ACCESSION NBR: 7911150348 DOC. DATE: 79/11/07 NOTARIZED: NO DOCKET #
 FACIL: 50-275 Diablo Canyon Nuclear Power Plant, Unit 1, Pacific Gas 05000275
 50-323 Diablo Canyon Nuclear Power Plant, Unit 2, Pacific Gas 05000323
 AUTH. NAME: CRANE, P. A. AUTHOR AFFILIATION: Pacific Gas & Electric Co.
 RECIP. NAME: STOLZ, J. F. RECIPIENT AFFILIATION: Light Water Reactors Branch 1

SUBJECT: Forwards revised Figure 2 showing actuator pressure relief sys re Attachment A of 790927 ltr. Valve qualification program requested is not required at facility.

Re: Docket No. 50-275-OL
Docket No. 50-323-OL
Diablo Canyon Units 1 and 2

Figure 2
Revised 10-29-79

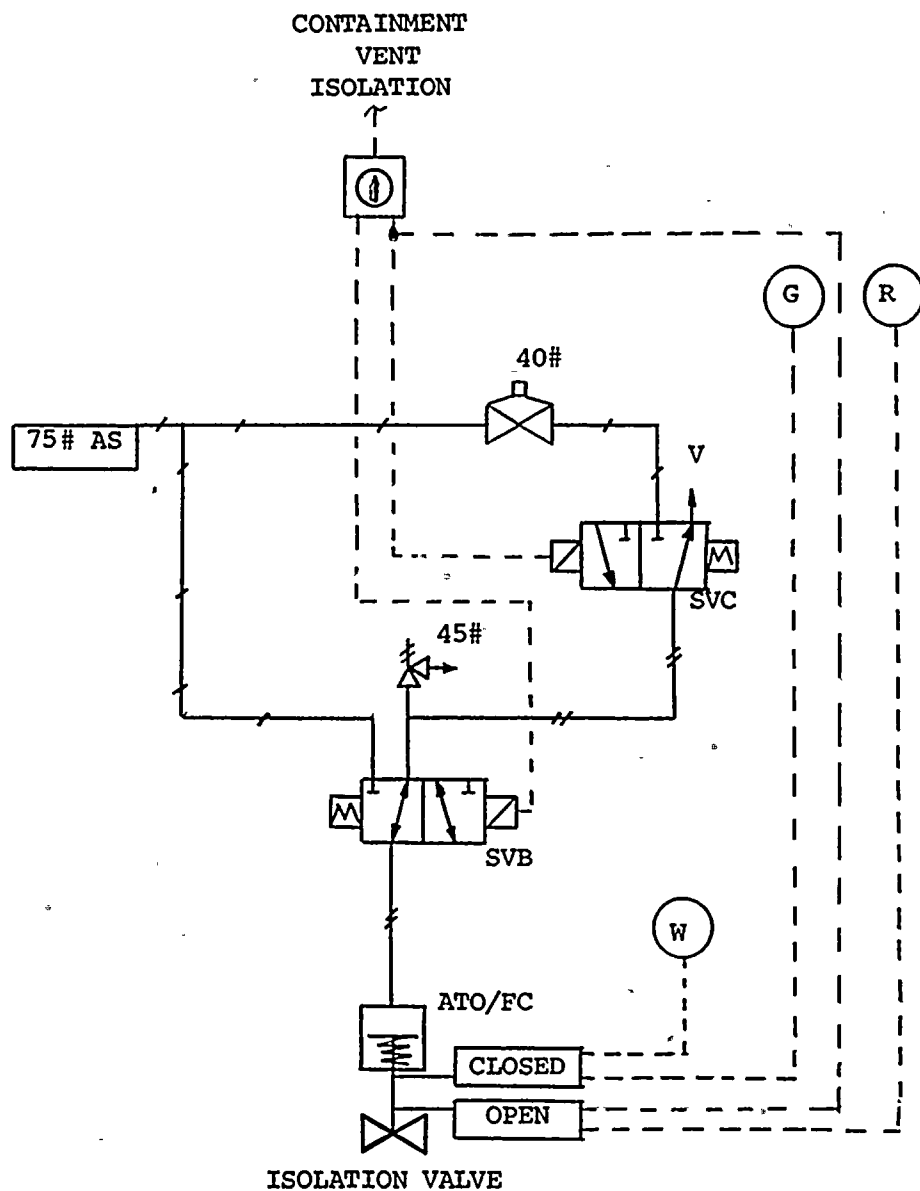
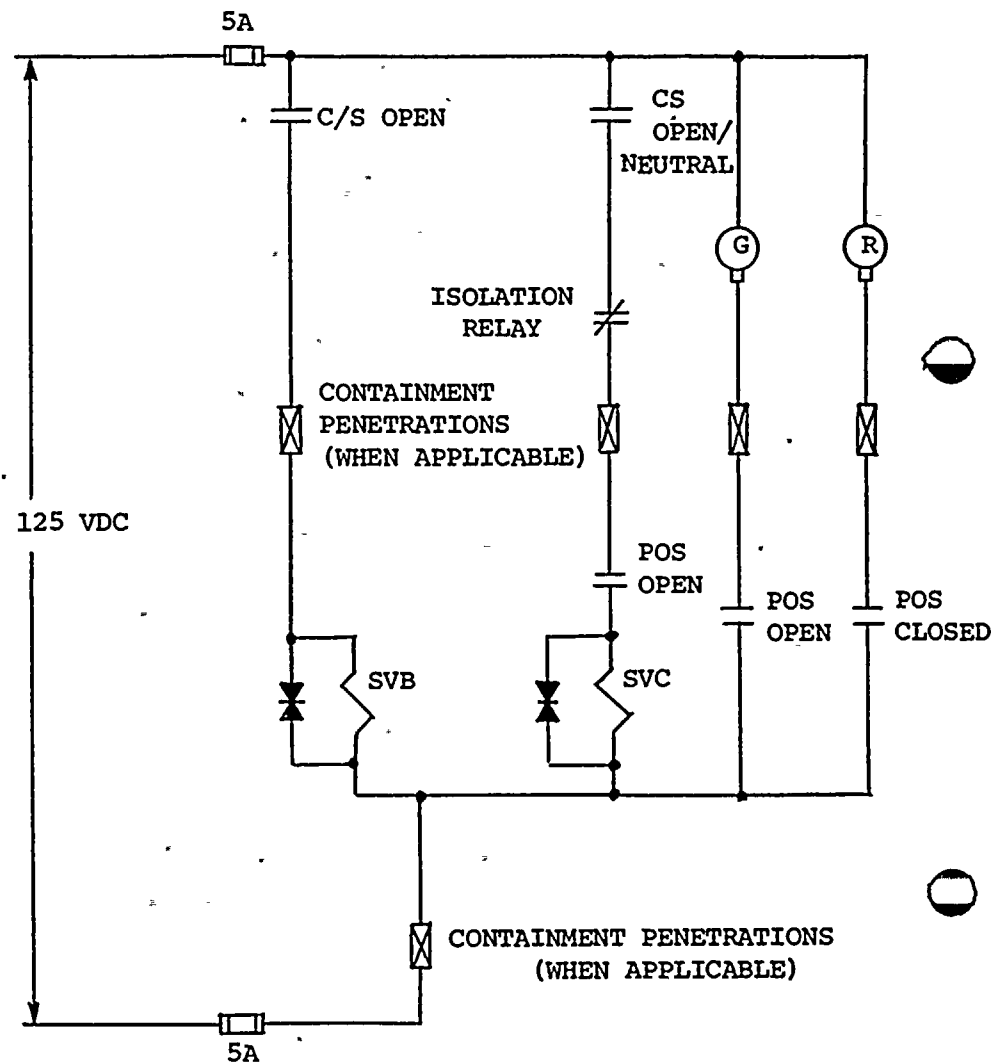
In our letters of September 27, 1978 and April 13, 1979 we responded to your letters of March 21, 1978 and March 14, 1979, respectively, on the subject of Containment Purging. In our submittals we addressed the problems of differential pressure and the resulting loading of the design basis LOCA by explaining our solution of installing a protective relief valve which will prevent the pressure in the valve pneumatic actuator from building up to a point where the valve shaft would be exposed to excessive torques. In Attachment A to our September 27, 1978 submittal we included a Figure 2 which schematically represented the Actuator Pressure Relief System as it was being installed. Subsequent testing of the system dictated changes. Attached is a revised Figure 2 which shows the system as installed.

Based upon our system design, the valve qualification program requested is not required at Diablo Canyon.
